TREE CONSTRAINTS PLAN

Site Address:
Westcourt Primary School
Silver Road
Gravesend
Kent
DA12 4JB
Client:
The Primary First Trust

By: C. Barkel
Date: 05 December 2022
Ref: WC/TCPI2068-02
Scale: 1:200 @ A3

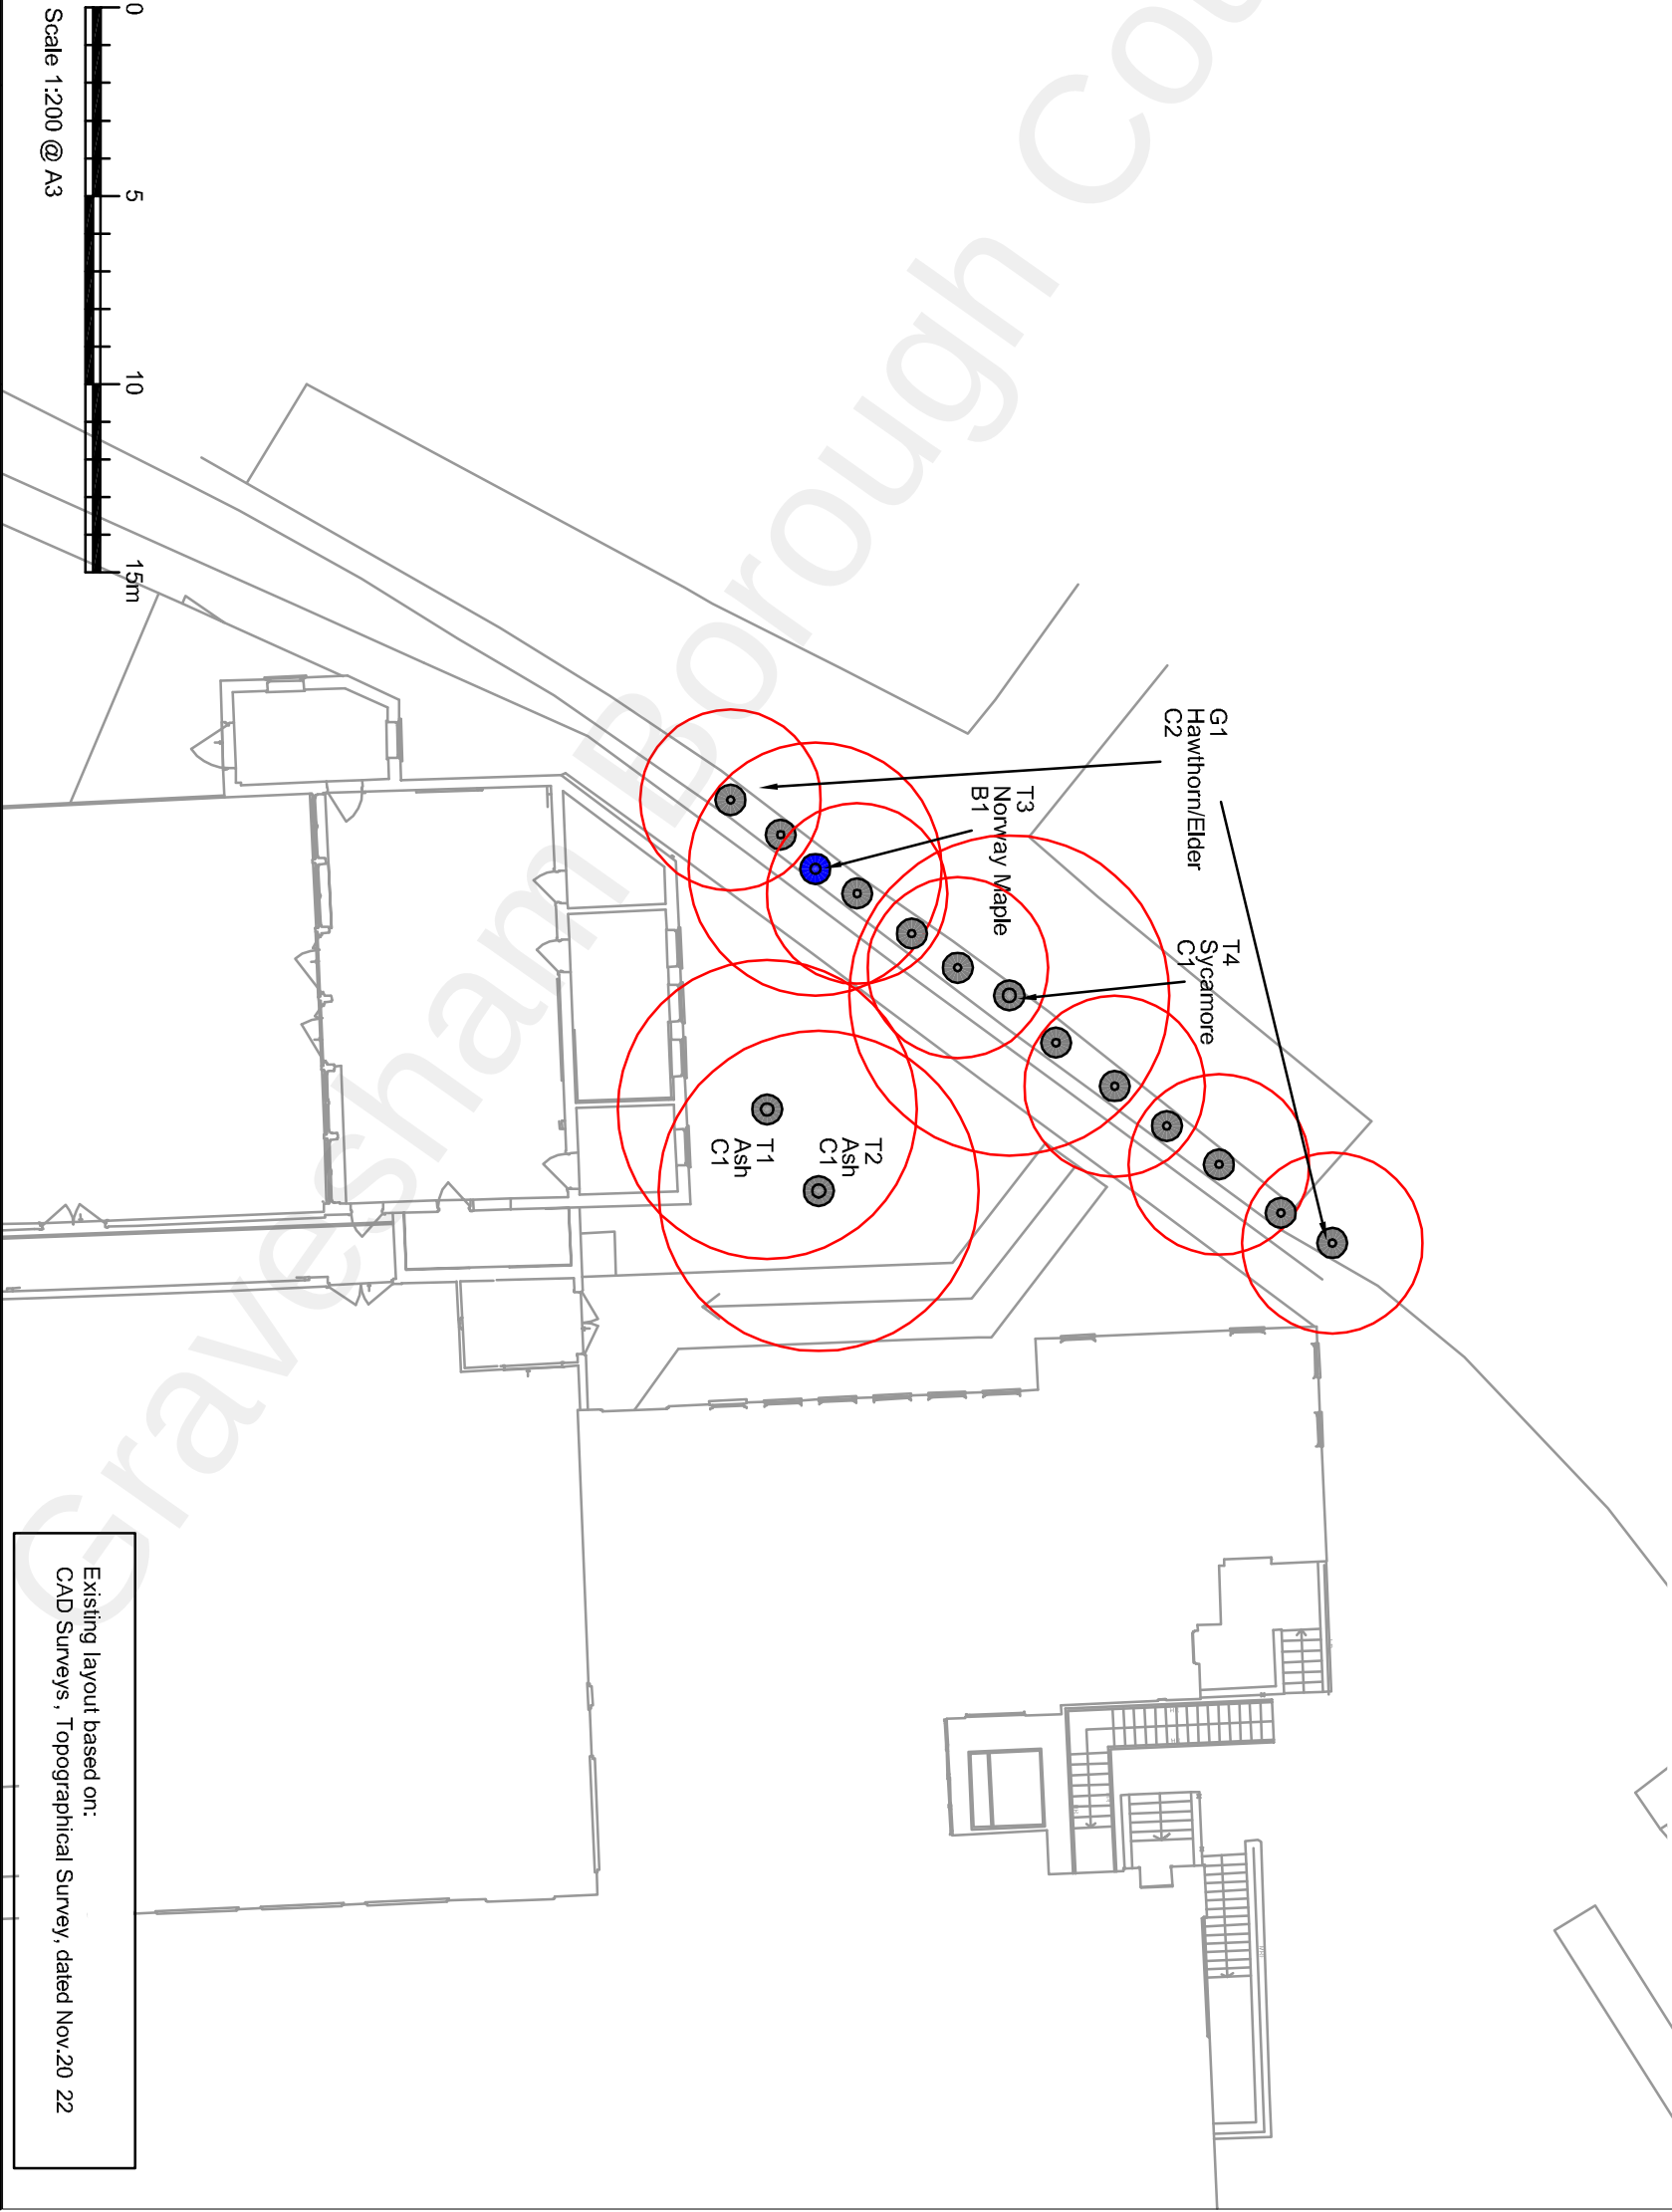
The Rooting zone of this tree extends into the area of proposed development and as such precautions will be required to avoid damage to the tree, with all proposed works adhering to BS5837.

The proposed hard surfacing within the RPA of this tree will ideally need to be permeable and built up over existing ground level.

It would be preferable to minimise the extent of hard surface incursion within the RPA, with as much soft landscaping retained as possible.

Trees T1, T2, T4 These trees are of low value and are likely to be considered to be acceptable to remove to accommodate proposals. If retained the same considerations will be required as advised for tree T3.i.e. permeable surfacing built over existing ground levels.

In order to comply with the British Standard the surfacing should not exceed 20% of the existing unsurfaced RPA. The proposals as currently designed show over 50% incursion into the RPA of T2, as such it is likely that this tree would need to be shown for removal for the purposes of planning.

Due to the proximity of T1 to the building and the tree not being of particularly good form, it may be worth considering the removal of both T1 and T2, with replacement specimen trees provided on the area of grass to the front of the nursery. This would also help facilitate construction.

Trees G1 These trees form a boundary hedgerow, this provides valuable screening, as well as habitat. Although of low arboricultural value it would be viewed positively by planning if this group was retained, as such the same principles for any proposed surfacing (or re-surfacing) within the RPA's will apply i.e. fully permeable and built over existing ground level (or within the depth of any existing surfacing).
